L-169.75

## RE: Rural Municipality of La Broquerie - Wastewater Treatment Lagoon Expansion - Environment Act Proposal

Please find attached revised plans L1, L2, L3, L4 and L5 which addresses your request for additional information as indicated in your January 27, 2016 letter. Text from your January 27, 2016 letter is in *italics*.

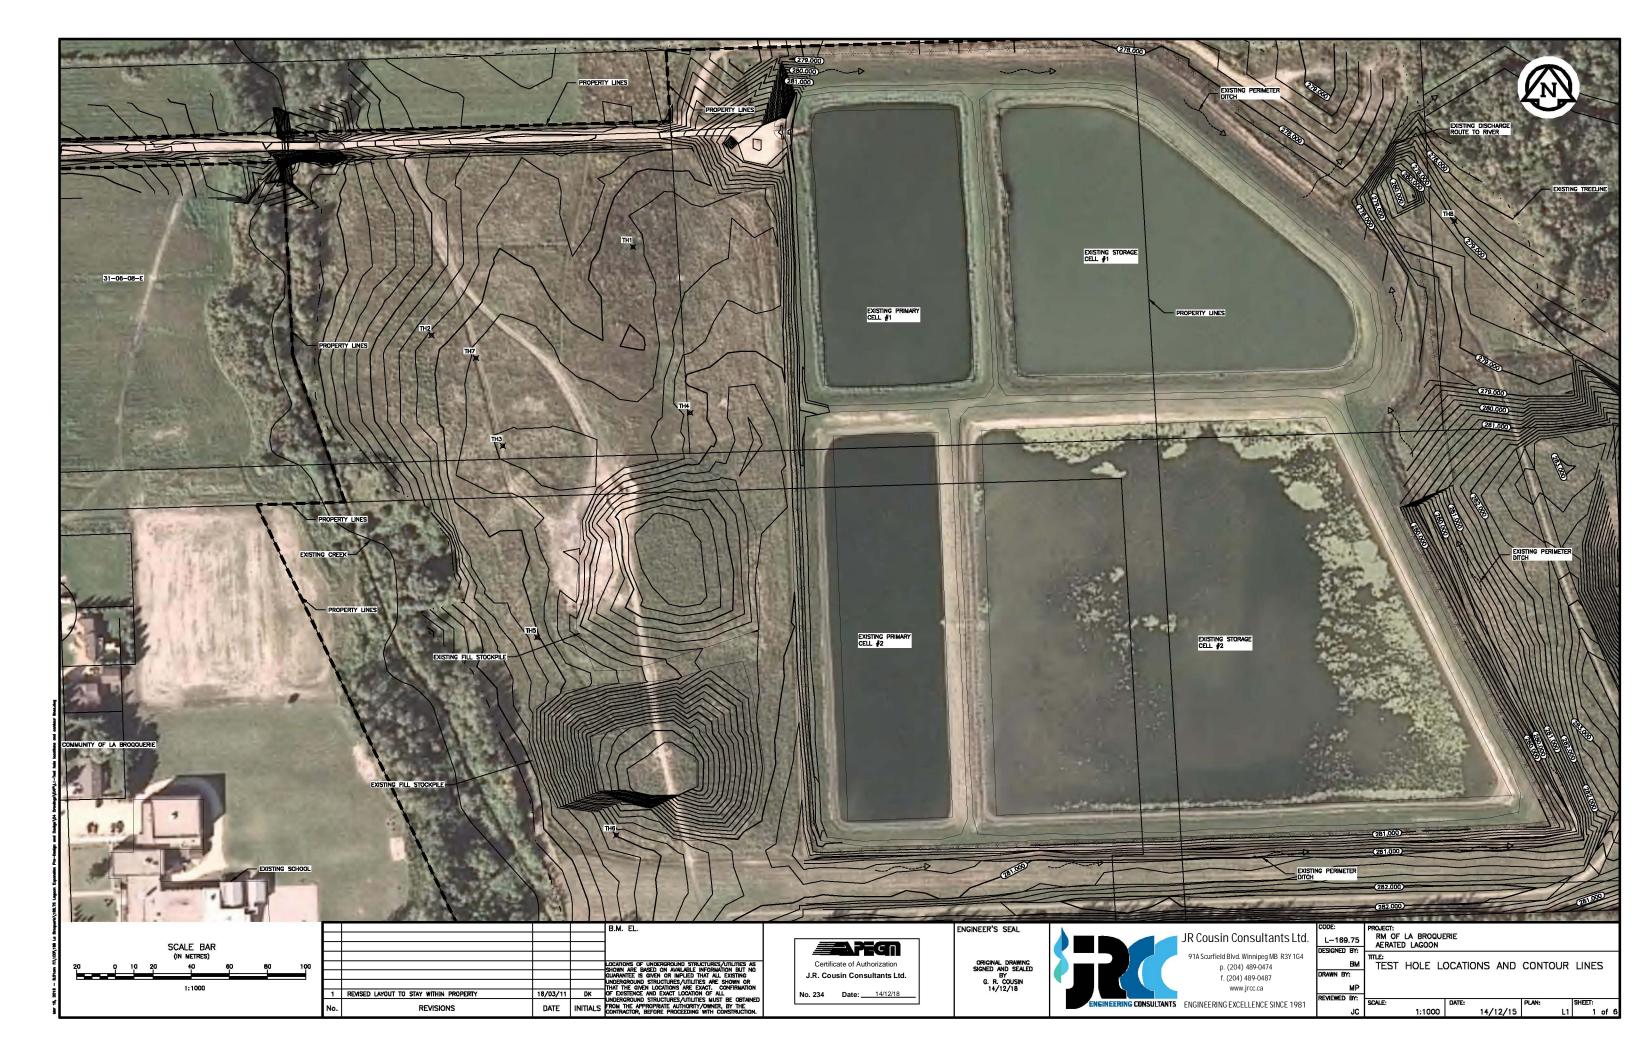
- 1. "All property lines adjacent to or associated with the site of the expanded lagoon, including easements and immediately adjacent properties;" Property lines are shown and labeled on plan L1.

- 6. "Locations and configurations of all soil stockpiles and other materials associated with previous lagoon construction activities, including all soil and other materials that may have been placed at the site and on adjoining properties;" Locations of soil stockpiles are indicated on Plan L1

- 7. "Topographies of lands owned by the Rural Municipality of La Broquerie and immediately adjacent lands that are privately owned and located between the existing lagoon and the Seine River." Elevation contours are shown on Plan L1.

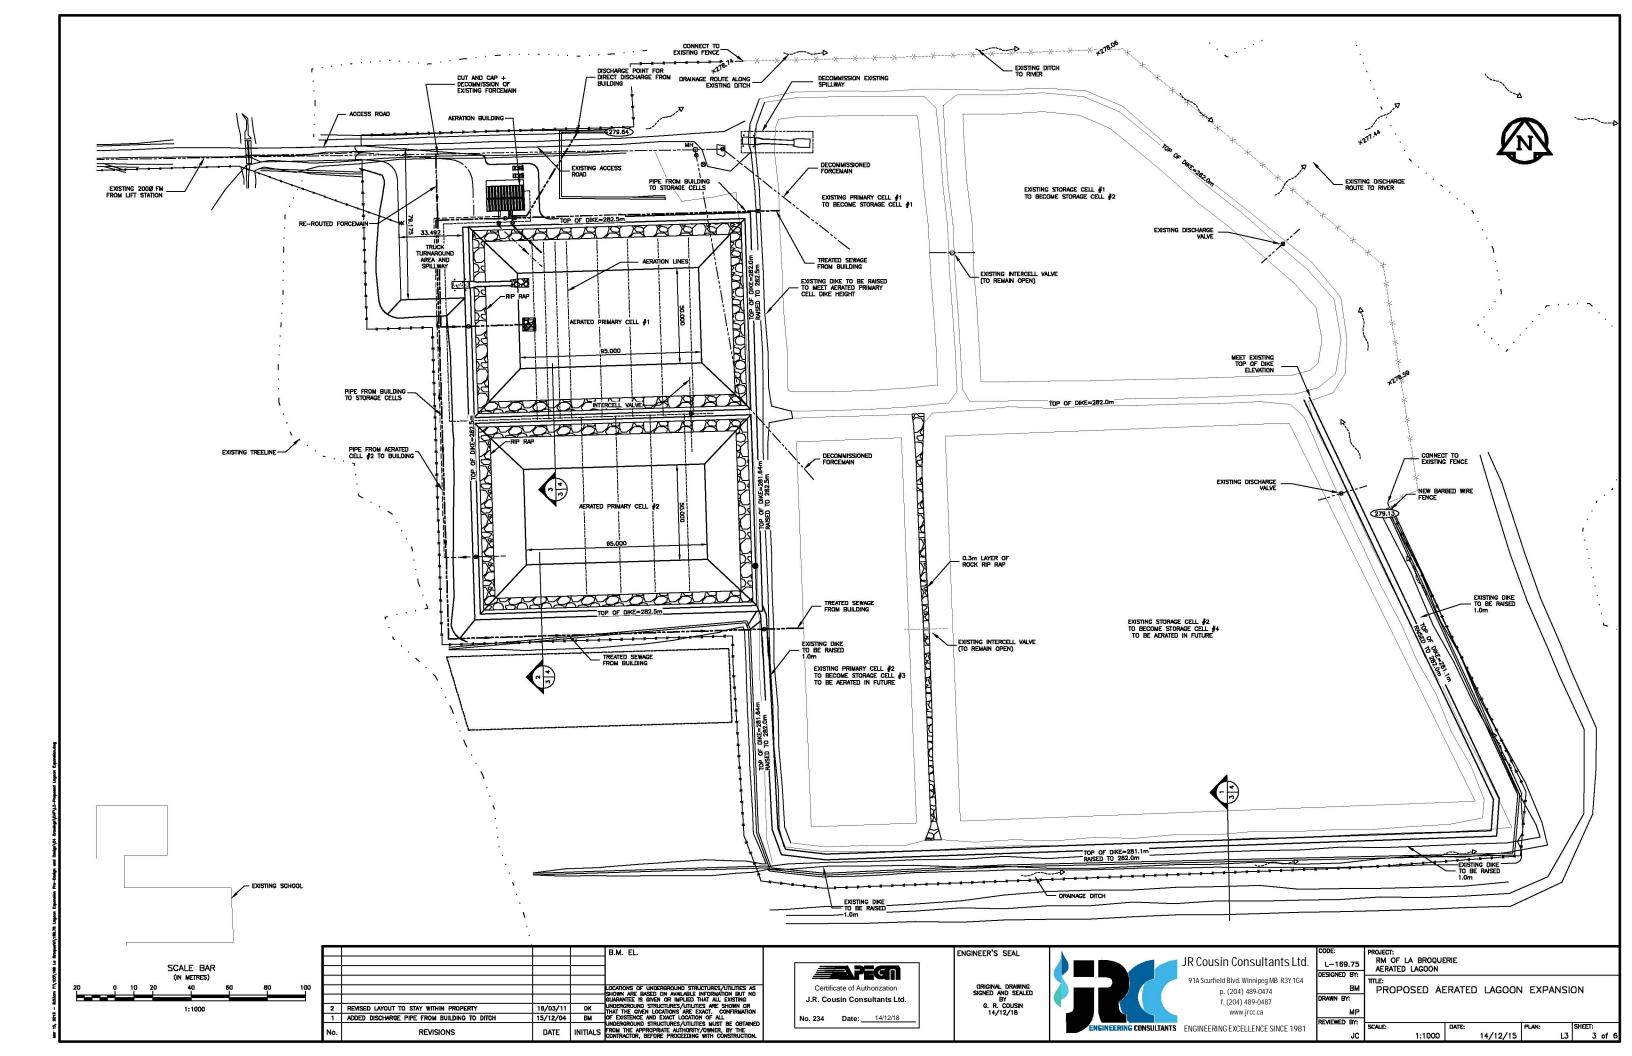
- 2. "Specific locations or proposed area and site drainage and discharge ditches;" Ditches are shown on Plan L3.
- 3. "Specific Locations of proposed discharge pipe outlets;" Discharge locations are shown on Plan L3.

- 4. "Specific locations of existing and proposed fences and gates;" Fence and gate locations are shown on Plan L3
- 5. "Elevations of key points along the lagoon drainage routes to the Seine River;" Elevations are indicated where new ditching meets existing drainage ditching on Plan L3. Existing drainage ditches to the Seine River will be utilized and re-graded if required to ensure positive drainage.

RM OF LA BROQUERIE AERATED LAGOON DIKE CROSS SECTION AND FENCE DETAILS AS NOTED 14/12/15

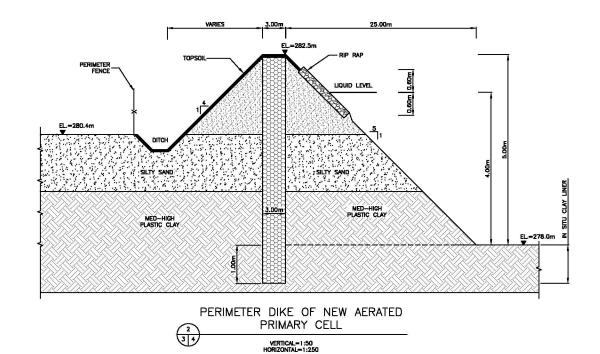
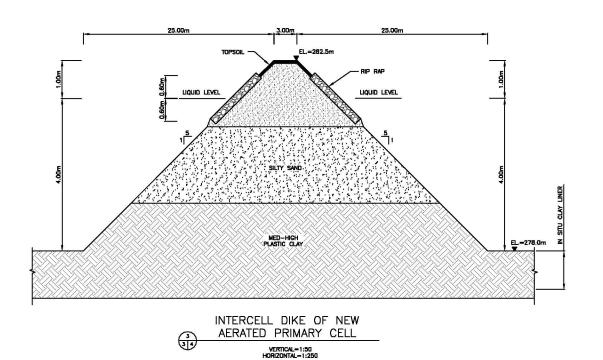
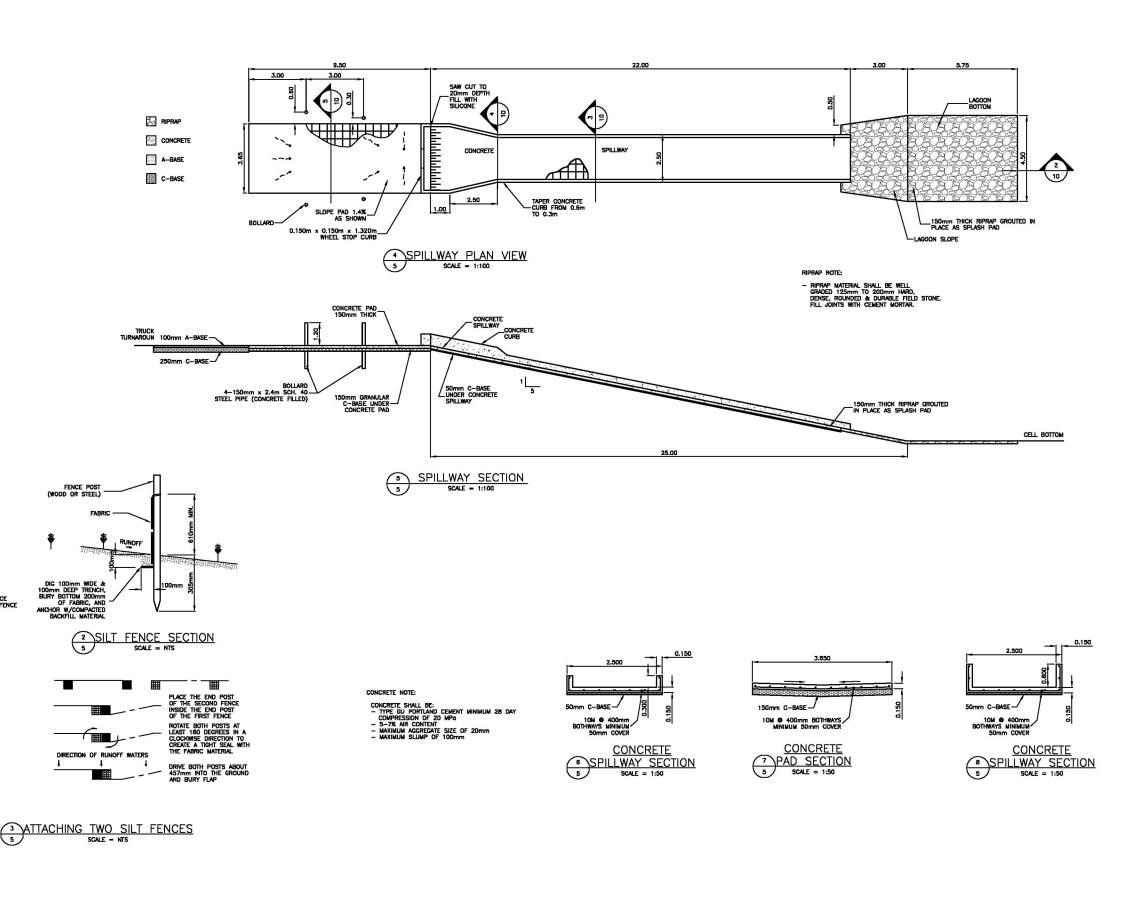
Plans L2, L4 and L5 have been modified as required to keep the proposed lagoon expansion inside of RM of La Broquerie property. The aeration cell operating depth has been revised from 3.5 m to 4.0 m.
